THIS REPORT IS A FIELD STRUCTURAL SITE ANALYSIS OF THE EXISTING CONDITIONS OF THE NORTH ELEVATION UNDERLYING WYTHES OF MASONRY AFTER THE STONE VENEER REMOVAL. SITE ANALYSIS ALSO INCLUDED THE EXTG. CONDITIONS OF THE 2 X 12 ROOF RAFTER ASSEMBLY & RECOMMENDATIONS FOR REMEDIATION.

FIELD STRUCTURAL SITE ANALYSIS EVALUATION REPORT

SUBJECT PROPERTY: 35 N. BROADWAY, AURORA IL. 60505

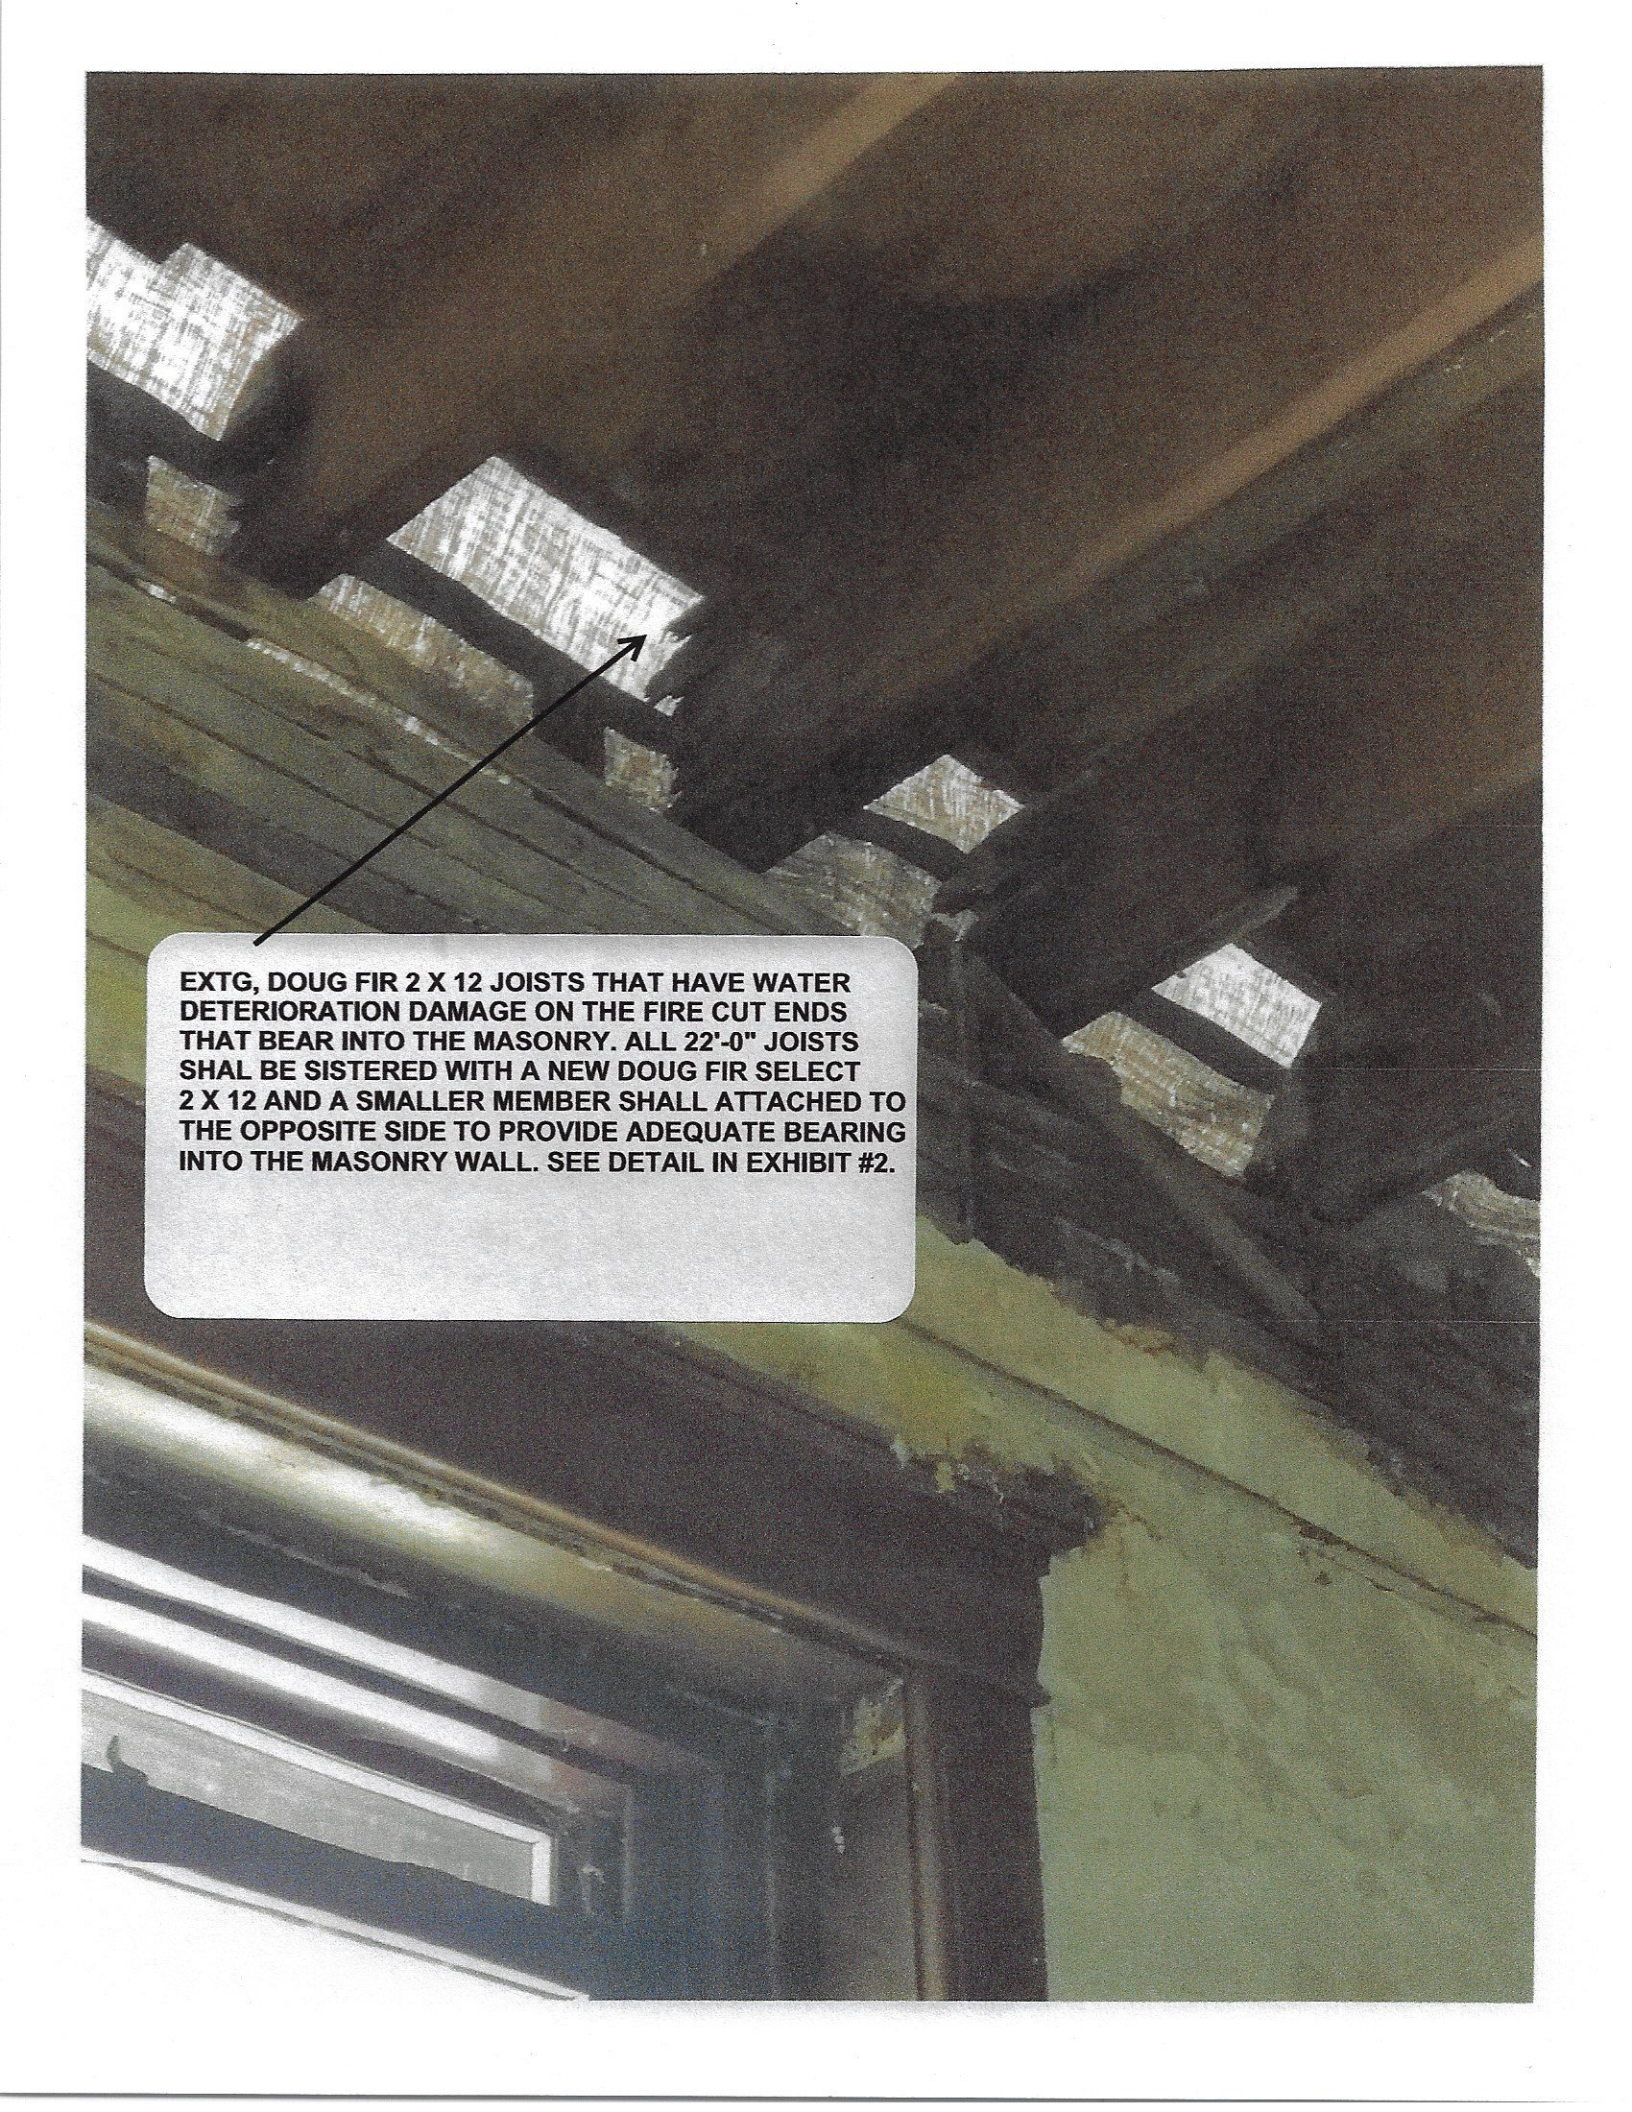
EXTG. CONDITIONS OF WATER DAMAGED AND DETERIORATED FIRE CUT ENDS OF EXTG. 2 X 12 DOUG FIR ROOF RAFTERS. WE ARE RECOMMENDING THAT ANY DAMAGE MEMBERS BE REPAIRED & SISTERED PER THE ENCLOSED DETAIL IN EXHIBIT #2, PRIOR TO COMPLETION OF MASONRY.

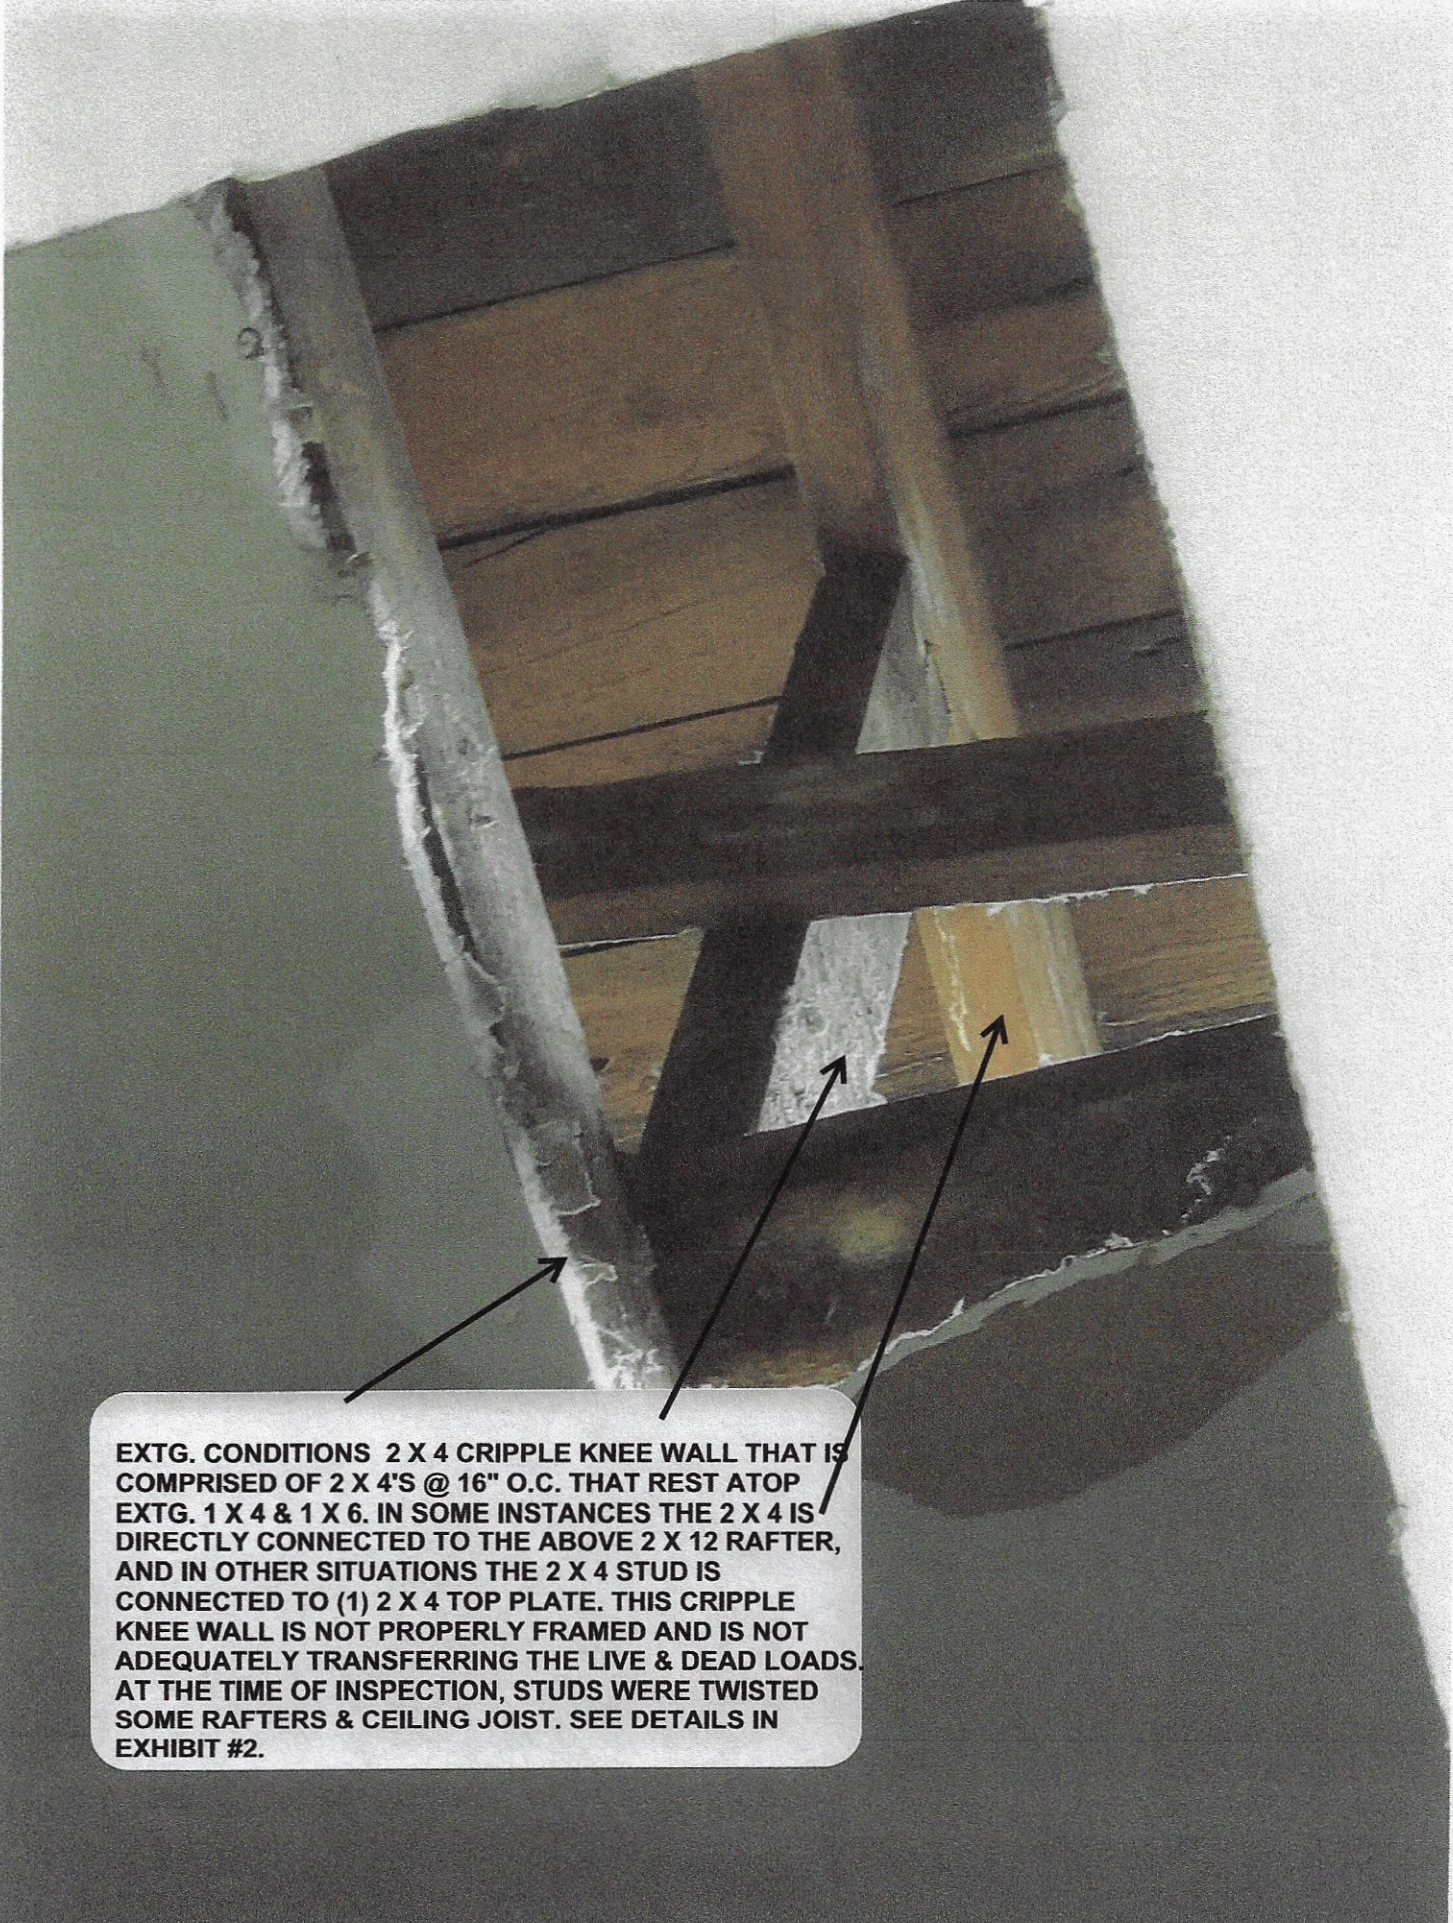
EXTG. CONCRETE DENTAL PATTERN & CONCRETE CORNICE EXHIBITS QUITE A BIT OF DEAD LOAD THAT IS NOT ADEQUATELY SUPPORTED. THIS CONDITION ALSO EXIST ON THE FACADE ON BROADWAY. THE PINS ARE RUSTED AND WATER PENETRATION HAS CREATED SOME DETERIORATED AREAS. WE ARE RECOMMENDING REPLACEMENT OF THESE (2) ARCHITECTURAL ELEMENTS WITH NEW GFRC PANELS FOR DENTAL & CORNICE WORK. THE REPRODUCTION IS EXACT AND WILL BE ABOUT 1/3RD OF THE DEAD LOAD WEIGHT. SEE EXAMPLE IN DETAIL #2
